## Metro Tower Site Plan Amendment No. 82019011A

- Request to modify the design of the below-grade parking garage to provide up to 73 additional parking spaces within one-and-a-half additional below-grade levels. No changes to density, height, or exterior building design are proposed.
- Located in the northwest quadrant of the intersection of Wisconsin Avenue and Elm Street in Bethesda
- 1.08 total acres zoned CR-5.0 C-4.0 R-4.75 H-175, CR-5.0 C-5.0 R-4.75 H-250, and Bethesda Overlay Zone, in the 2017 *Bethesda Downtown Sector Plan*
- Applicant: 7316 Wisconsin LLC.
- Acceptance date: February 19, 2020
- Review Basis: Chapter 59, Section 59.7.3.4.J.1.a.

Staff recommends approval of Site Plan Amendment 82019011A to increase the maximum number of parking spaces from 160 to 233, and make associated adjustments to the data table and overall public benefit points. All site development elements shown on the latest electronic version as of the date of this Staff Report submitted via ePlans to the M-NCPPC are required except as modified by the following conditions.<sup>1</sup> The following Condition 8.a.i. supersedes the previous Condition 8.a.i., while all other previously approved cond

Figure 3 – Metro Tower Site Plan Amendment

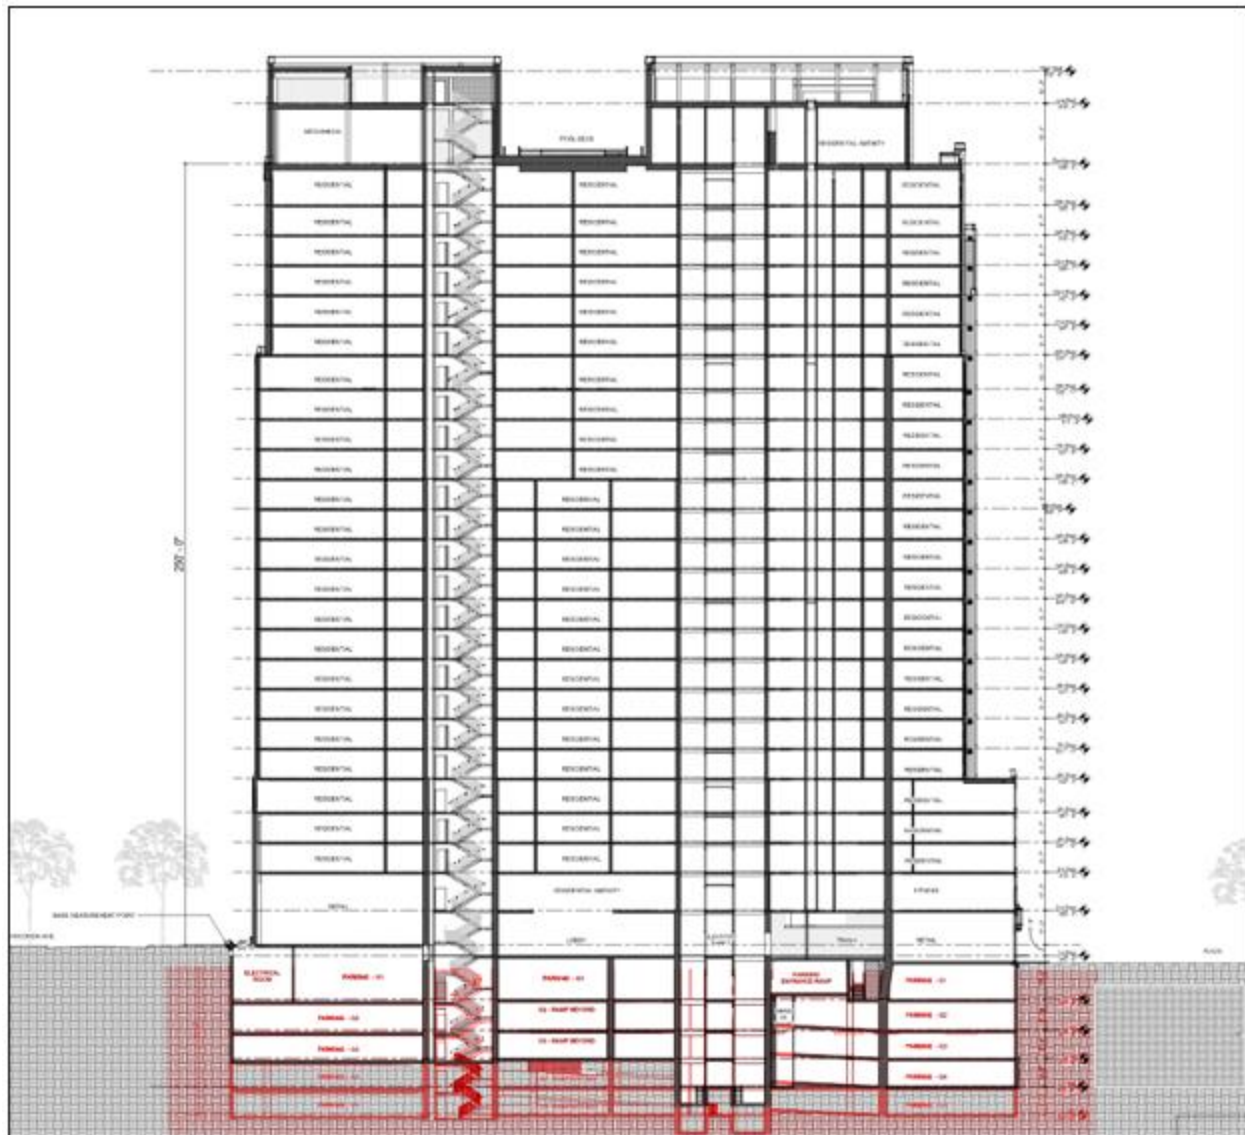
The Applicant requests to increase the number of parking spaces from an approved maximum of 160 to 233, modify the Minimum Parking public benefit category in Condition 8.a.i. to reflect the increase in parking spaces and update the data table and public benefit points accordingly.

The increase of up to 73 parking spaces will inversely reduce the public benefit points for Minimum Parking from 17.7 points to 12.7 points. The overall public benefit points will decrease from 120.7 to 115.7. However, the project will still be above the 100-point minimum requirement. The increased parking will be accommodated within one-and-a-half additional below-grade levels. No changes to density, height, or exterior building design are proposed.

- i. Minimum Parking – The Applicant must not provide more than 233 parking spaces, all of which must be unbundled from the sale or lease of the proposed dwelling units.
